Exhibit “B”

Memo

Subject: Engineering Land Use Comments for Sports Complex on SW Corner 4th and Baseline

Date: September 26, 2022

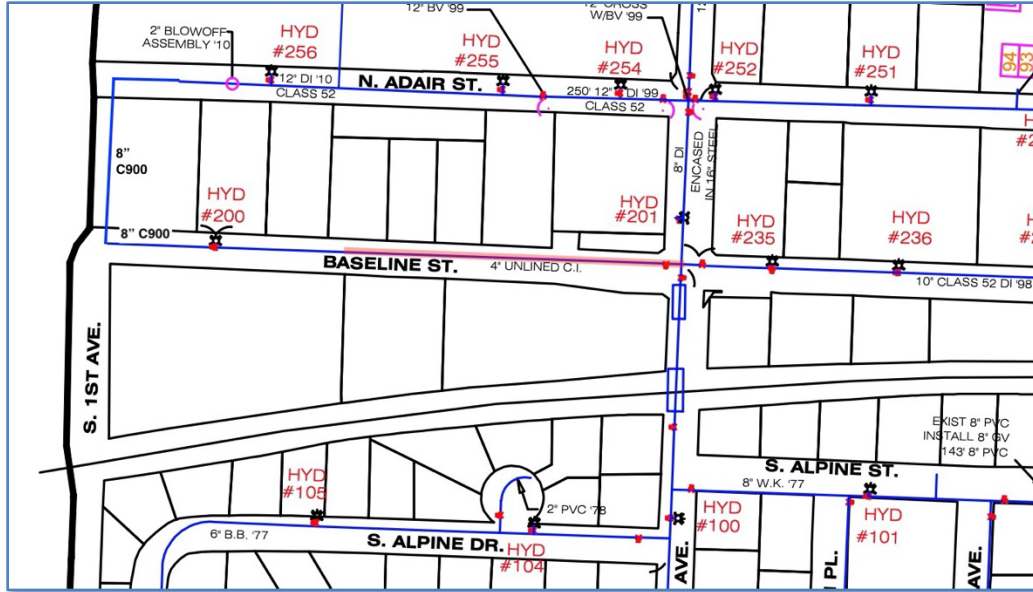
An 8-inch ductile iron water main exists on 4th Avenue adjacent to the site. This main meets current standards. A 4-inch unlined cast iron water main exists along the Baseline frontage that does not meet standards.

The applicant is required to replace the water main along the Baseline frontage with an 8" C900 pipe. The area where this replacement is necessary is shown in the map below with red shading.
